Re: PETITION NO. 1120 – The United Illuminating Company
180 Hawthorne Drive, Fairfield Connecticut

Re: Petition No. 1120- The United Illuminating Company Petition for a Declaratory Ruling that no Certificate of Environmental Compatibility and Public Need is required for the proposed modifications to the Hawthorne Substation at 180 Hawthorne Drive, Fairfield, Connecticut.

I have reviewed most of the material submitted by the UI and offer the following comments to ensure a thorough review and perhaps address concerns about the project -pending additional information regarding Stormwater and UI responses to Town of Fairfield's second set of Interrogatories, dated March 11, 2015 in connection with the above referenced petition.

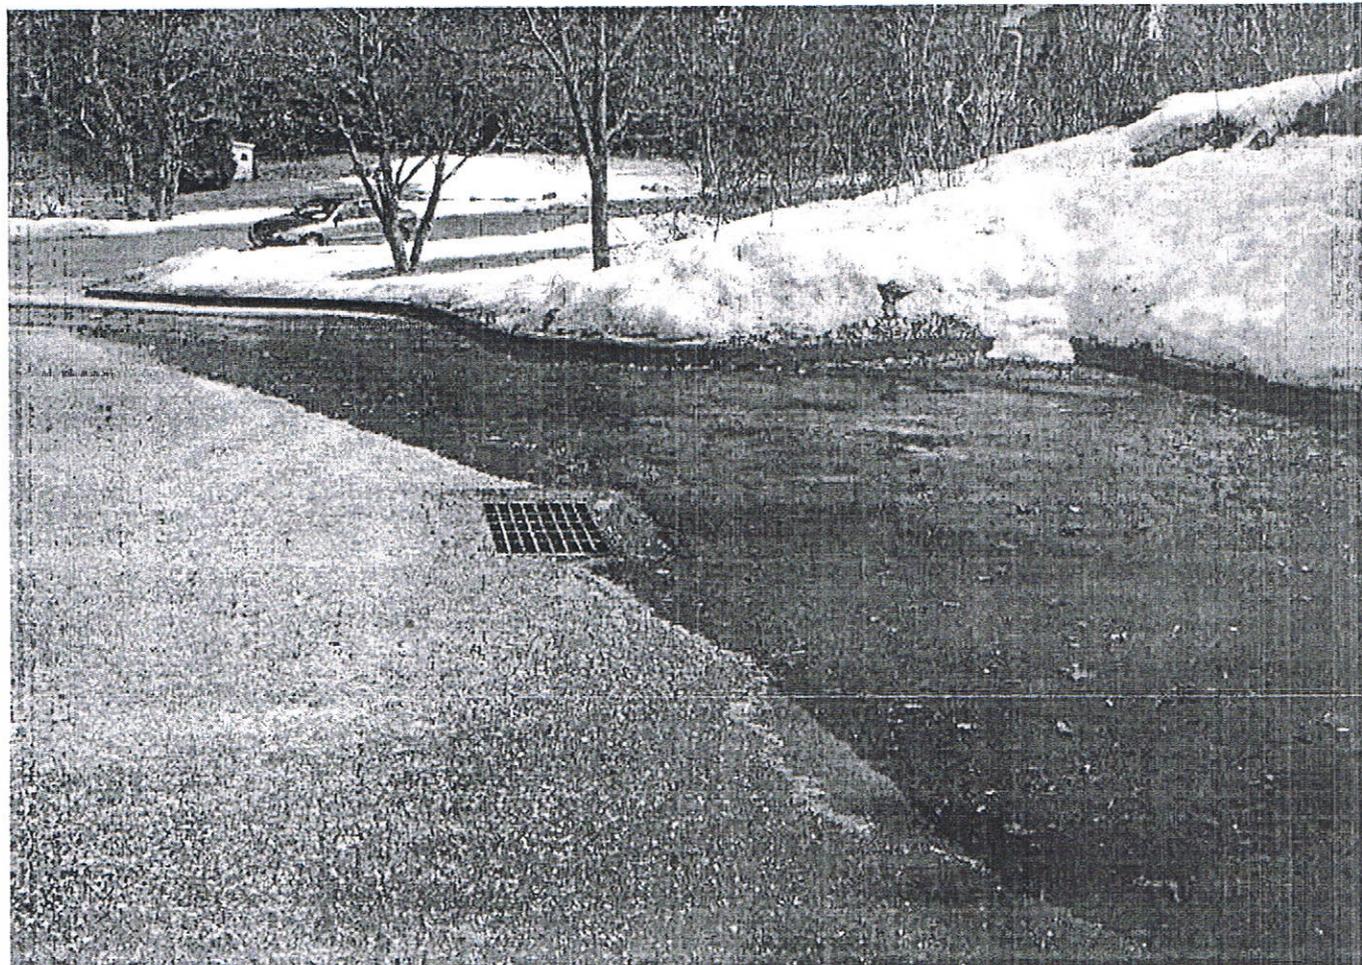
The Stormwater Pollution Prevention Plan often states that the catch basin at the lower part of the site will perform several functions of collecting runoff and preventing off site impacts. See enclosed photo to see how Catch Basin is performing. UI should propose to regrade/redirect runoff and include double basin, trench drain or relocate basin to collect this runoff.
